# VTA's BART SILICON VALLEY— PHASE II EXTENSION PROJECT LOCATION HYDRAULIC STUDY

## E.1 Introduction

This Errata reflects the modifications to the *Phase II Extension Project – Location Hydraulic Study* that may have resulted from comments received during the public review of the Supplemental Environmental Impact Statement (SEIS) and Subsequent Environmental Impact Report (SEIR) for the BART Silicon Valley Phase II Extension (Phase II) Project or that were required for purposes of clarifications. Changes to the *Location Hydraulic Study* shown in ~~strikeout~~ text for deletions and in underline text for additions.

Figure 7. Floodplain Map, Part 4 of 4 (revised)

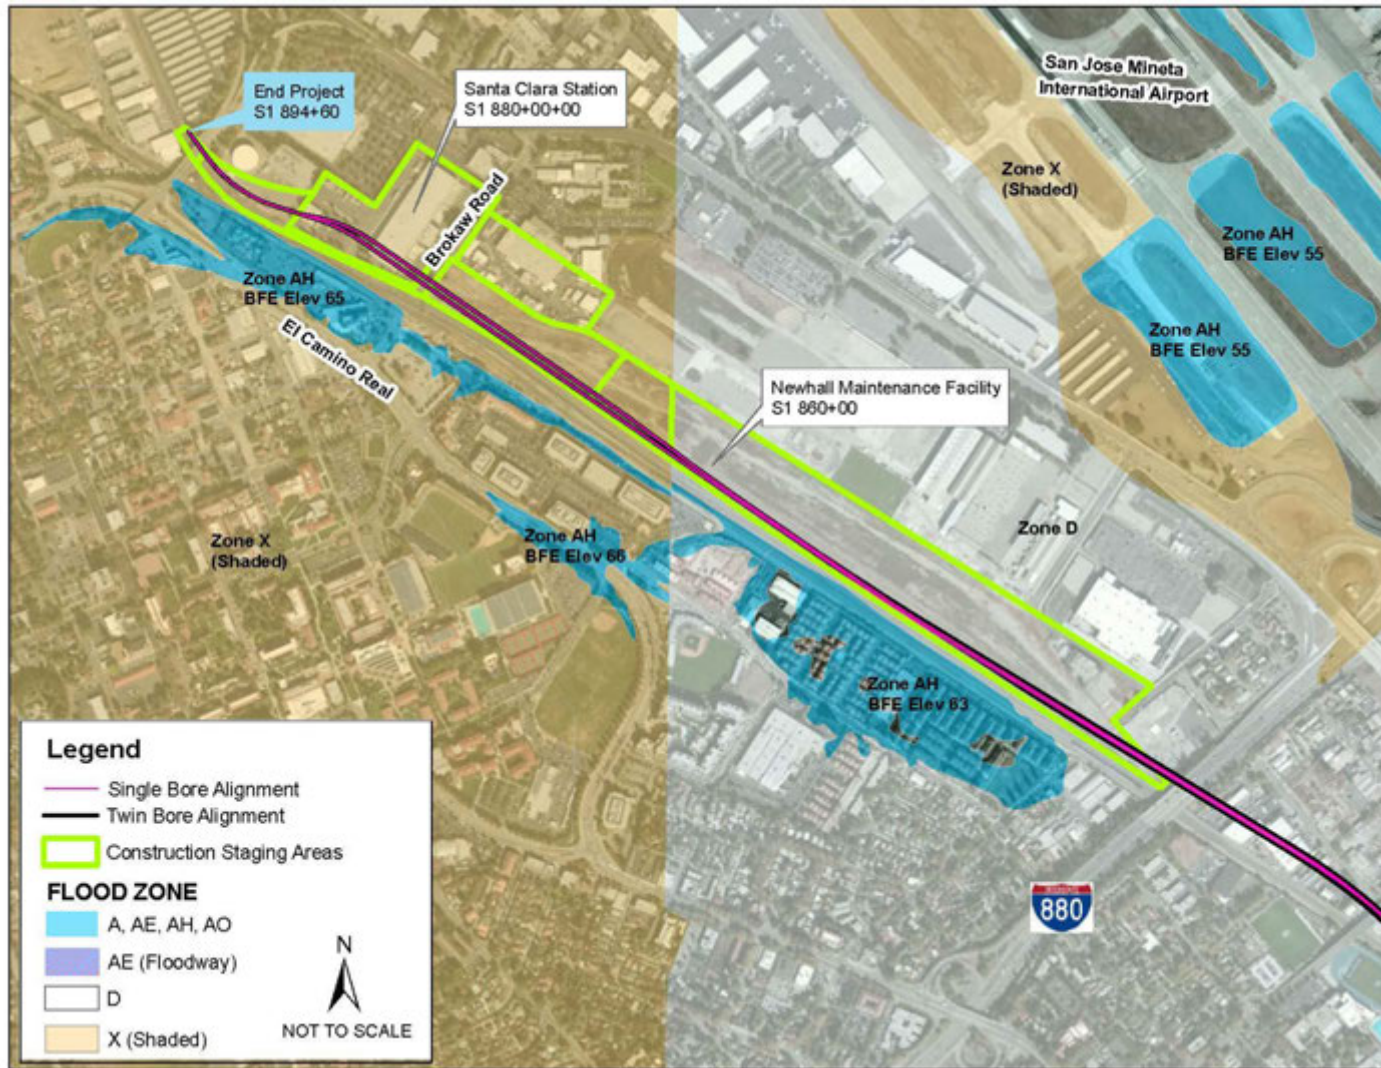
Figure 7 has been updated and is included on page E-4 below.

**Figure 1**  
**Regional Location (Revised)**  
 VTA's BART Silicon Valley-Phase II Extension Project

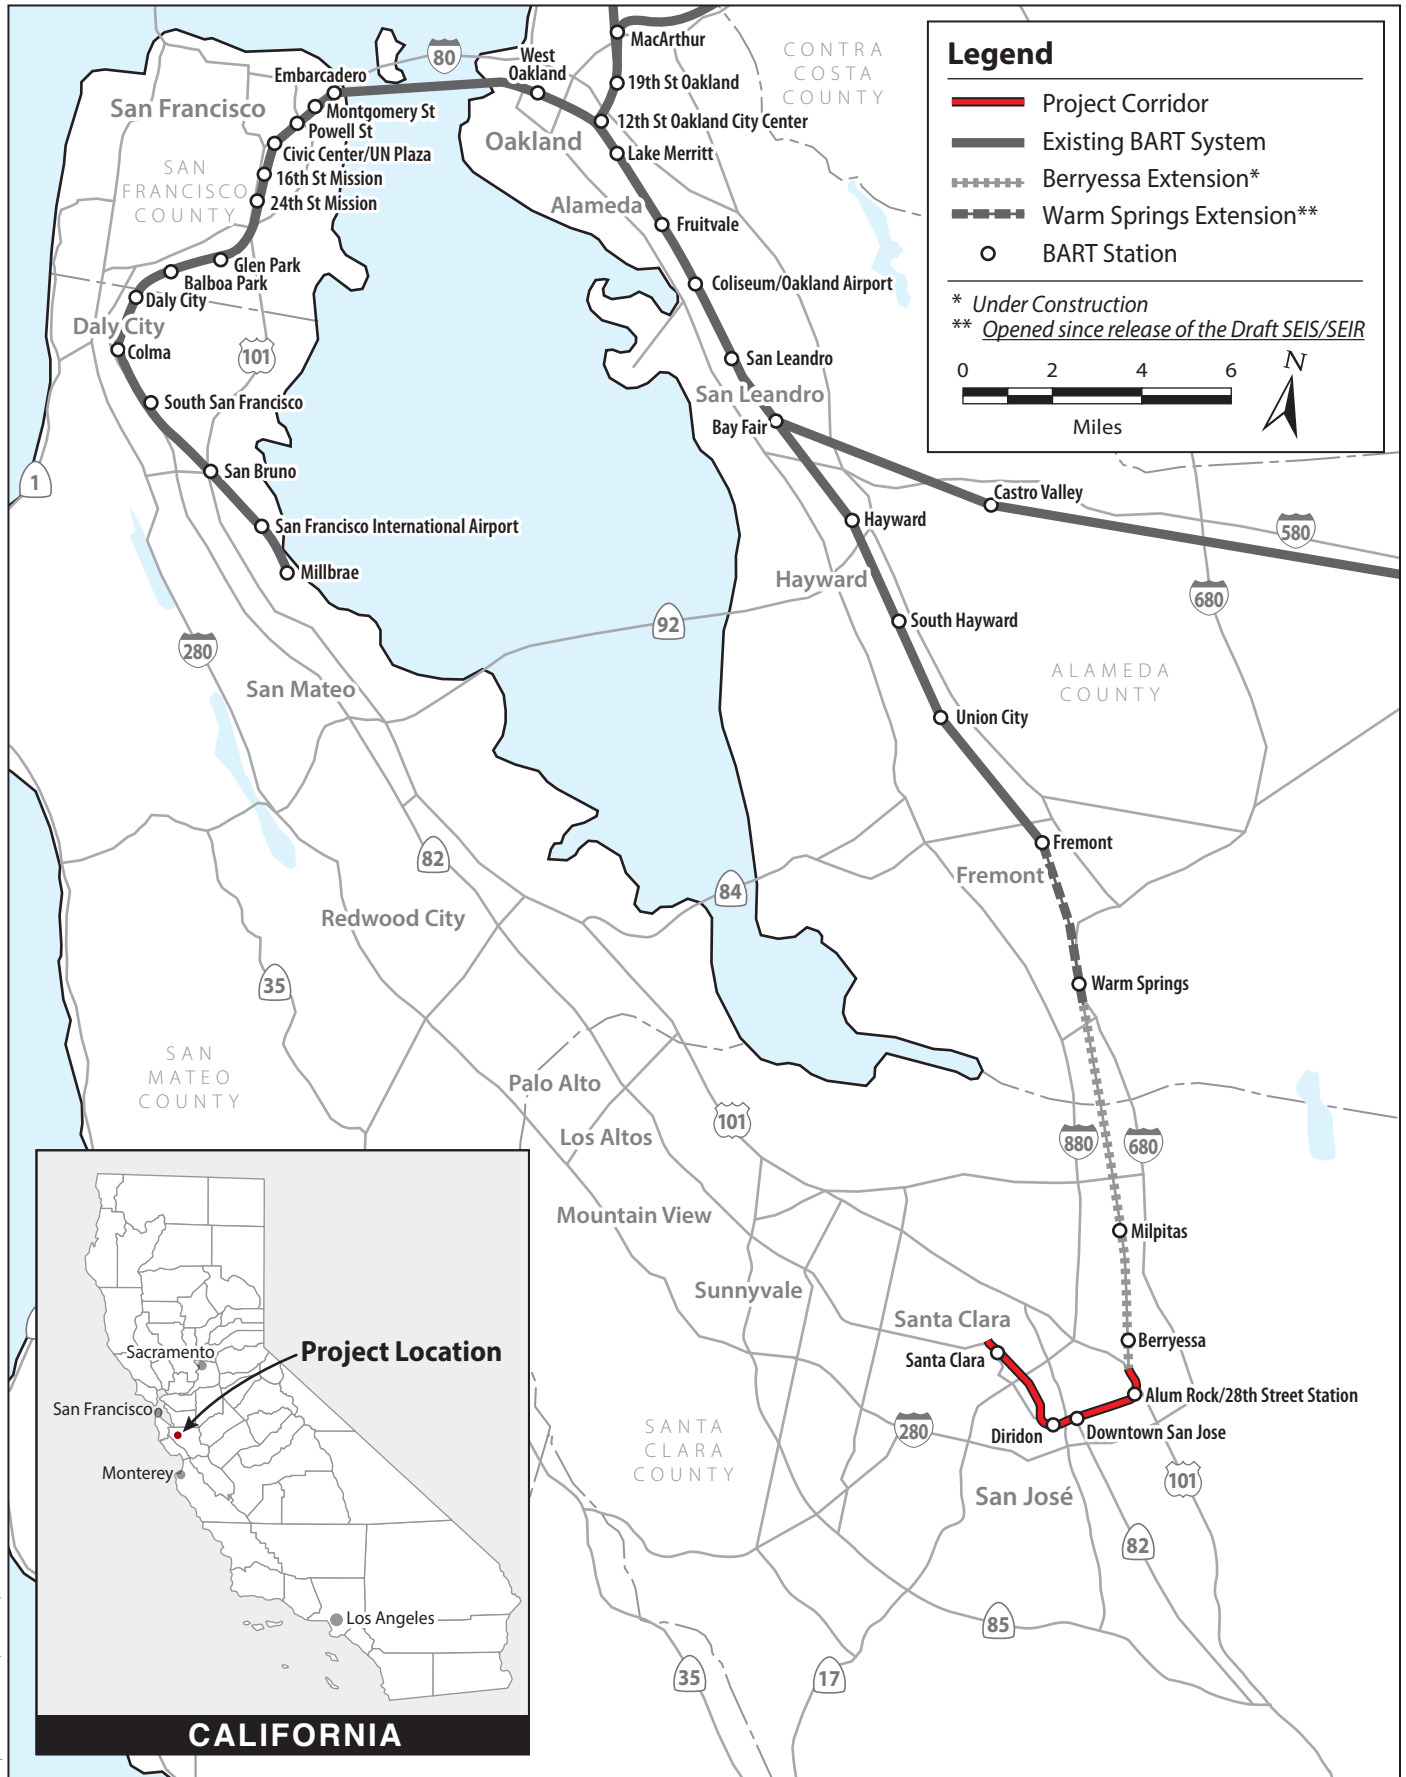
The alignment would transition from a retained-fill configuration east of U.S. 101 and south of Mabury Road near the end of the Phase I alignment into a retained-cut configuration and enter the East Tunnel Portal ~~near~~just north of Las Plumas Avenue.

**Figure 2**  
**BART Extension Alternative (Revised)**  
VTA's BART Silicon Valley – Phase II Extension Project

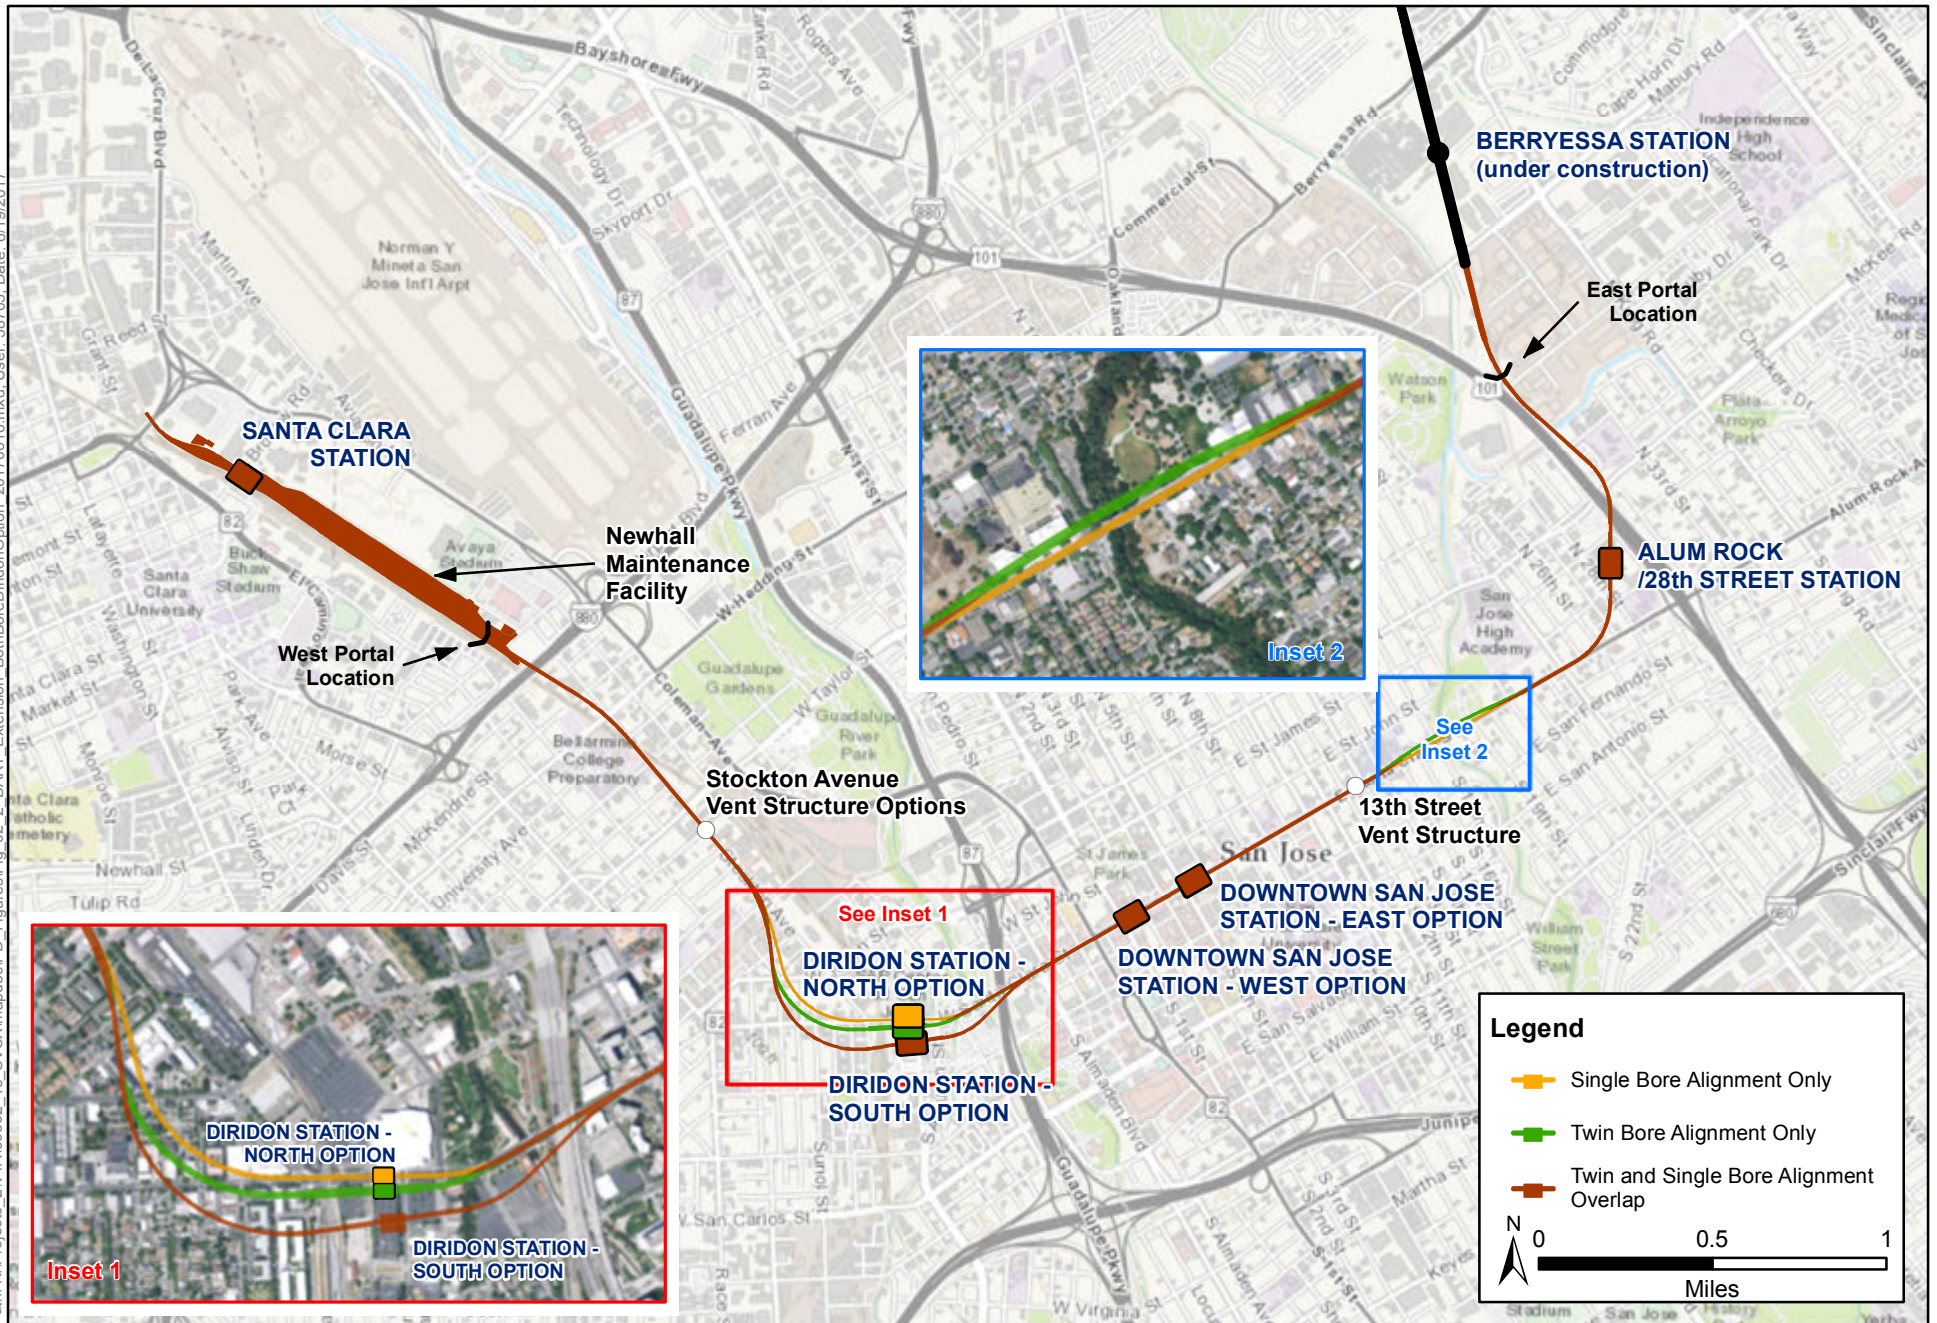
The alignment would continue beneath Santa Clara Street from the Downtown San Jose Station and shift south beginning just west of South ~~Almaden~~ Almaden Boulevard to pass between the SR 87 bridge foundations. For the Twin-Bore Option, the alignment would pass ~~4540~~ 4540 feet below the riverbed of the Guadalupe River, ~~pass beneath~~ pass beneath and a retaining wall west of the river, and ~~over 2025~~ over 2025 feet below the creekbed of Los Gatos Creek. For the Single-Bore Option, the alignment would pass approximately 50 feet below the riverbed of the Guadalupe River, pass under the retaining wall, and approximately 35 feet below the creekbed of Los Gatos Creek. After passing under Los Gatos Creek, the alignment for both options would enter the Diridon Station between Los Gatos Creek and Autumn Street.

Under the Twin-Bore Option, the alignment would continue beneath Santa Clara Street ~~from the Downtown San Jose Station and shift south beginning just west of South Almaden Boulevard to pass between the SR 87 bridge foundations. The alignment would then pass~~

~~45~~ then continue approximately 50 feet below the riverbed of the Guadalupe River and a retaining wall, then veer back north to a location just south of and adjacent to Santa Clara Street. The alignment passes ~~25~~ 30 feet below the creekbed of Los Gatos Creek. After passing under Los Gatos Creek, the alignment would enter Diridon Station ~~under~~ between Autumn and Montgomery Streets and directly south of Santa Clara Street. The Diridon Station North Option is closer to Santa Clara Street in comparison to the South Option.

Under the Single-Bore Option, the alignment would continue and remain beneath Santa Clara Street, and continue ~~45~~ 50 feet below the riverbed of the Guadalupe River and ~~40~~ 50 feet below the creekbed of Los Gatos Creek. ~~After passing under Los Gatos Creek, the alignment would shift north and enter Diridon Station.~~ The boarding platforms, with the Single-Bore tunnel, would be located between Autumn and Montgomery and White Streets, directly south of Santa Clara Street. The Diridon Station North Option is closer to Santa Clara Street in comparison to the South Option.
